Modification Recommended Service Note

N8946A - Autoranging System DC Power Supply, 200V, 140A, 10000W, 400 VAC

Serial Numbers: DE14290000 - DE15369999 without manufacturing ID Version "B"

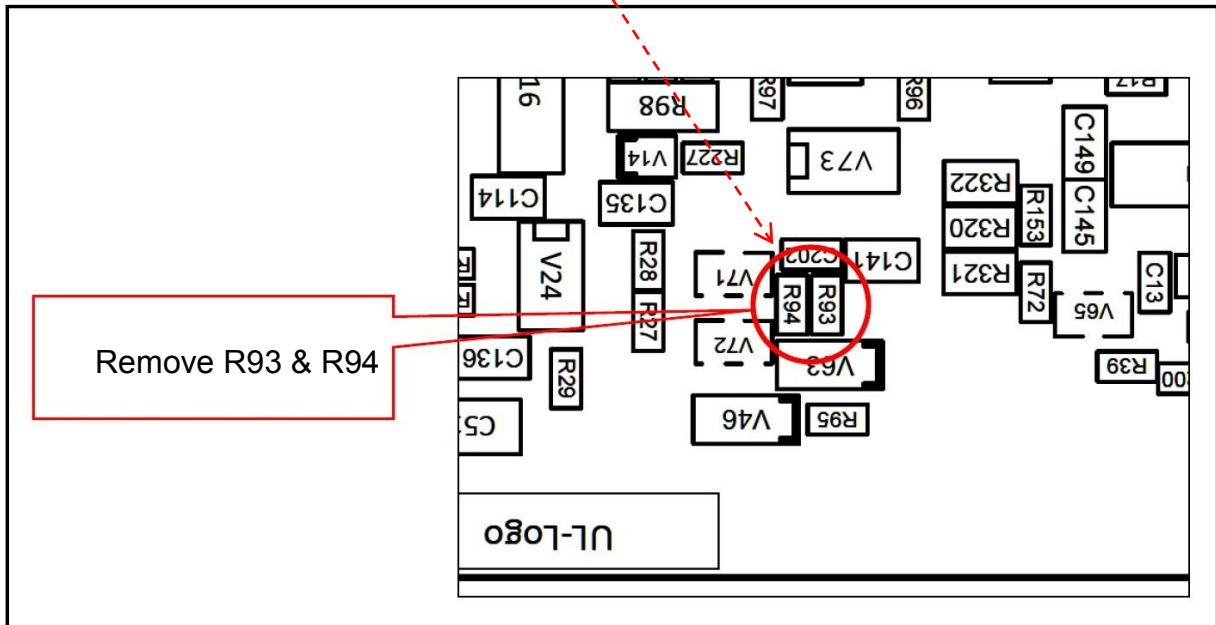
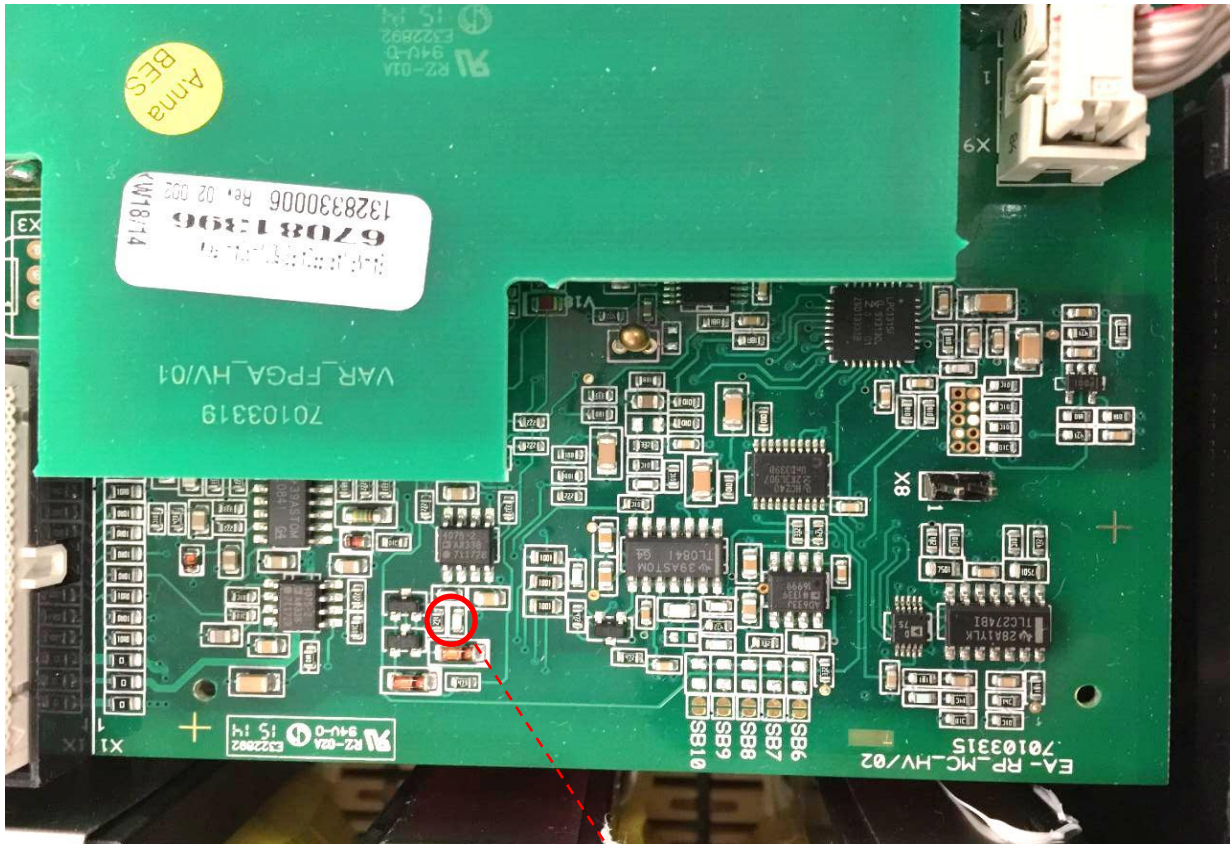
- 1) Remove acMains cable from power source.
- 2) Wait 5 minutes
- 3) Remove top cover from instrument.
- 4) In the 5kW units (viewed from the front of the unit), a small SMT assembly located at the right-rear of instrument will be readily visible (see below):

In the 10kW & 15kW units; although found in the same location, a black plastic cover will have to be removed to gain visibility and access to the SMT assembly. Plastic cover snaps-on and can be removed with a small screwdriver.

Suffix “B” added

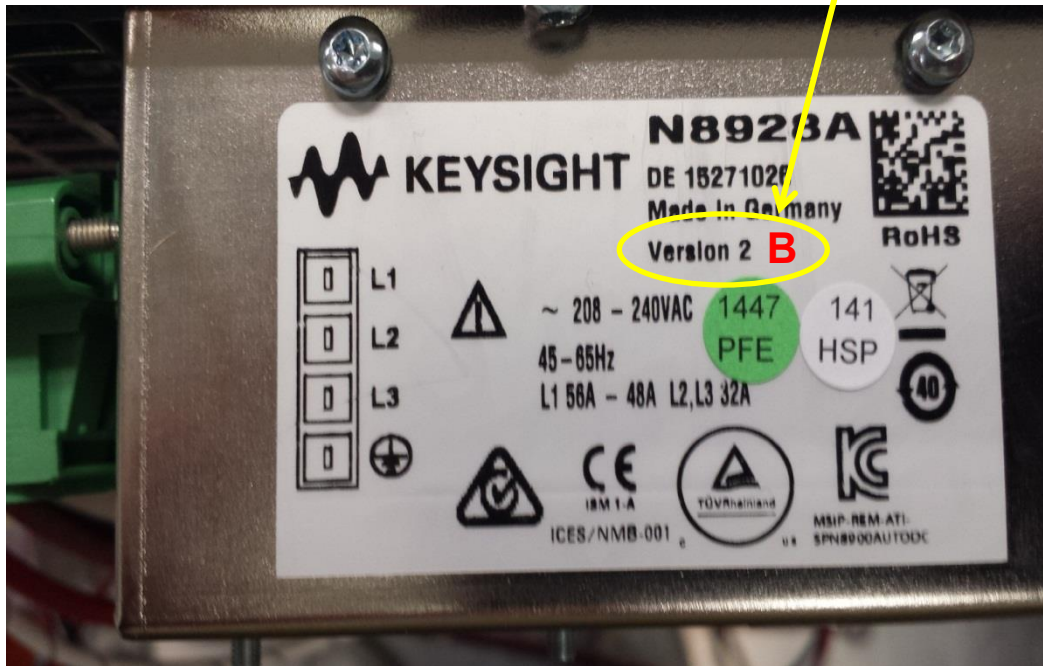
7) On the acMains label, on the rear of the instrument; use an indelible marker, to add the suffix letter “B” after the Version ID. This will assist in the tracking of modified instruments.
